preferred project report

mp 05\_0083  
pacific highway  
sandy beach north

prepared for  
Sandy Shores Developments

Job No: 9498a  
August 2010  
© Willana Associates Pty Ltd 2010  
ABN 93 868692799

**Figure 1 - Excerpt from the Coffs Harbour City Local Environmental Plan - Zoning Map**

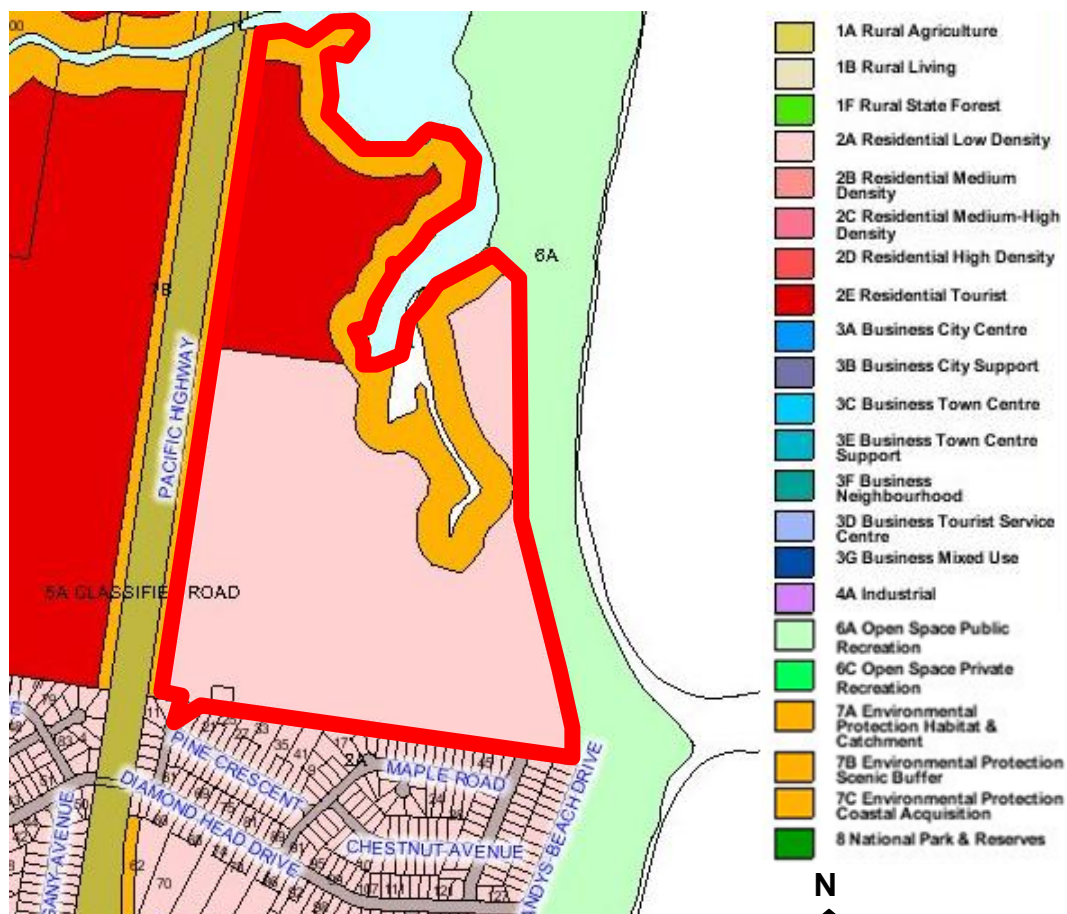
- The incorporation of land currently zoned 7A, under Coffs Harbour City Local Environmental Plan 2000 (CHCLEP), into the development for residential purposes, is not supported as it is not desirable for the long term management of the land.
- Noise barriers are not to be constructed on land zoned 7B as prescribed by the CHCLEP. Justification or discussion of the scenic impact is required.
- Clarity regarding the community title scheme is required for the public open space.
- Clarification needs to be provided regarding the site description and what lots are covered by this proposal.

At the eastern edge of Hearn's Lake, the concept plan provides for some deep residential blocks that extend into the 7A zone. There is also a small section of link road providing access to the development along the eastern side of the lake. The dwellings, and the access road, are permissible uses with the 7A zone and subdivision is permissible pursuant to Clause 18 of the CHCLEP. Whilst there are small areas where proposed allotments intrude into the 7A zoned land, the allotments are of such significant size that they can accommodate a dwelling in the 2A land, quite separate from the 7A portions.

The land zoned 7A on the site is predominantly proposed as open space and will provide the desired setbacks to the edges of Hearn's Lake. In many instances, the proposed areas of open space exceed the 7A land as identified in Council's zoning plan.

The concept plan also allows for significant areas of proposed open space that are outside the 7A zone and which are currently zoned 2A. This is a result of a considered and technical response to the design of the site, that is, a layout and proposed development footprint that responds to the features of the land despite the area being zoned for urban purposes.
